PD Modification Application: MM 25-0849

Zoning Hearing Master Date: January 26, 2026

Hillsborough
County Florida

AGENCY REVIEW COMMENT SHEET

8.2 Proposed Site Plan (Full) Option 2

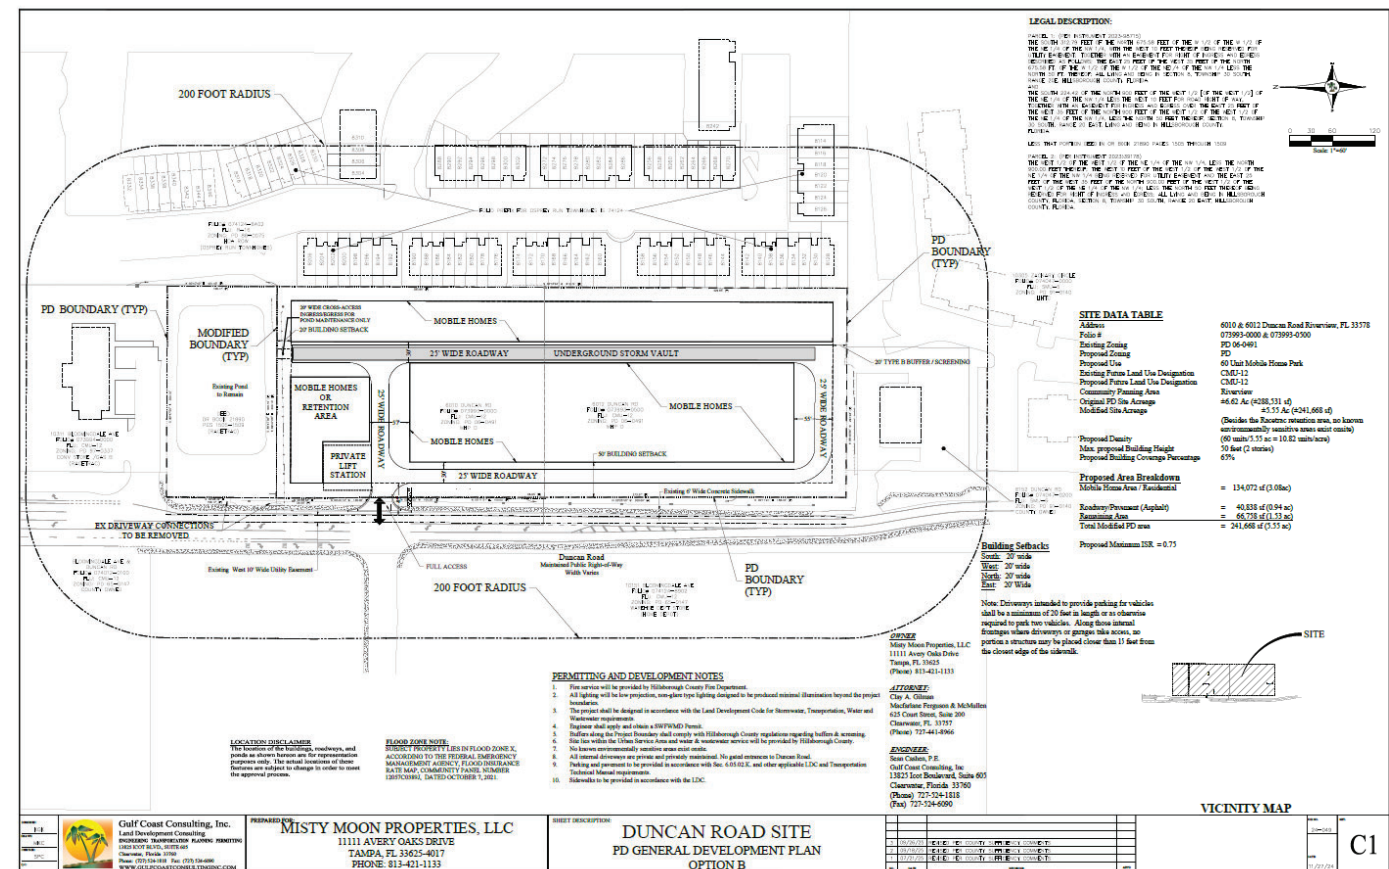
- Prior to PD Site Plan Certification, the developer will revise the Option B site plan to:
 - Change the label reading “20’ Wide Cross-Access Ingress/Egress for Pond Maintenance Only” to instead state “Proposed Access Stubout – See Conditions of Approval”.
 - Modify the note stating “Note: Driveways intended to provide parking for vehicles shall be a minimum of 20 feet in length or as otherwise required to park two vehicles. Along those internal frontages where driveways or garages take access, no portion a structure may be placed closer than 15 feet from the closest edge of the sidewalk.” To instead state, “Note: Driveways within which vehicles shall be permitted to park shall be a minimum of 20 feet in length (measured from the

closest edge of the sidewalk) or longer if required to accommodate the minimum number of required parking spaces within the driveway. Additionally, along those internal frontages where driveways or garages take access, no portion a structure may be placed closer than 15 feet from the closest edge of the sidewalk.”

- Remove the entire “Location Disclaimer” Note. Staff notes that PDs are site-plan-controlled zoning districts. While the applicant had the option of providing a conceptual vehicular and pedestrian system as provided by the DRPM, the applicant chose to present defined road rights of way, which are not conceptual. Only minor deviations are permitted at the time of plat/site/construction plan approval. Other changes may require the applicant to request a zoning modification.

The applicant has provided for a connection to the Pond Site, as further discussed above. The applicant incorrectly labeled such access as a “cross-access”. Rather, such access must be simply an “access”, since the intent is to allow the Racetrack development to access the pond through portion of the PD which is the subject of this modification request, rather than just allow for the exchange of trips between these two portions of the site. Staff has proposed a condition to correct this issue hereinabove.

The applicant filed a Sec. 6.04.02.B. Administrative Variance (AV) from the throat depth standard; however, such AV was not supported by the County Engineer. As such, the applicant agreed to a zoning condition requiring them to reconfigure the internal roadway system to a compliant configuration.

5. Notwithstanding anything shown on the PD site plan or herein these conditions to the contrary, prior to site plan approval the developer shall redesign the internal roadway system such that there is a minimum of 125 feet between the closest edge of the Duncan Rd. through lane and the closet edge of the intersection of the internal roadways. Additionally, no access (other than to the lift station) shall be permitted within this 125-foot area (i.e. the throat).
